# Planning and Land Use Department Planning Commission Staff Report

**Case No:** 2025-10706  
**Hearing Date:** July 17, 2025  
**Applicant:** City of Santa Fe Midtown  
Redevelopment Agency.  
**Agent:** Lisa Gavioli, NV5, Inc  
**Request:** Master Plan Amendment  
**Location:** 1600 St. Michaels Drive  
**Case Mgr.:** Joel Cruz-Haber  
**Zoning:** C-2 PUD (General Commercial)  
**Overlay:** Midtown LINC Overlay District  
**Pre-app Mtg:** N/A  
**ENN Mtg:** June 3, 2025  
**Proposal:** The applicant proposes amendments to the master site plan's development standards regulating plan and sub-zone designation that align with its core vision, intent goals, and objectives, and further policy directives for the areas as stated in the Midtown Community Development Plan, the Midtown LINC overlay district, and the General Plan.

**Case #2025-10706. Midtown Master Plan Amendment.** , 1600 St. Michaels Dr. NV5, Inc, Agent for Daniel Hernandez, Director of the Midtown Redevelopment Agency, Applicant, request a master plan amendment to the Midtown Master Plan on 64.22 +/- acres. The property is zoned C-2 PUD (General Commercial Planned Unit Development) and within the Midtown Local Innovatio

**Figure 1 Midtown Sub Zones & Façade Zones**

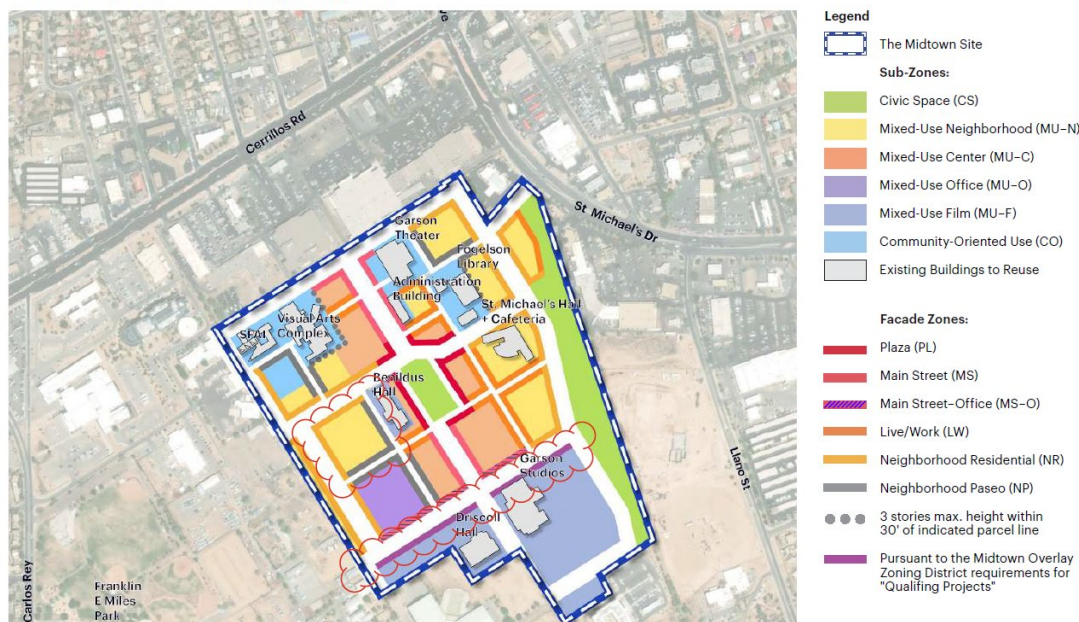
Page	Section	Current	Proposed
114.	5.4	Remove Façade Zone Standards Main Street-Office (MS-O) standards at MU-F northern façade zone	Remove Façade Zone Standards Main Street-Office (MS-O) standards at MU-F northern façade zone.
115.	5.4	Insert footnote stating that the northern façade zone of the MU-F will be pursuant to the Midtown Overlay Zoning District requirements for "Qualifying Projects".	Insert footnote stating that the northern façade zone of the MU-F will be pursuant to the Midtown Overlay Zoning District requirements for "Qualifying Projects".
		Tract O is currently designated subzone	Change Tract O (including Benildus) subzone to

115.	5.4	MU-N.	MU-C.
------	-----	-------	-------
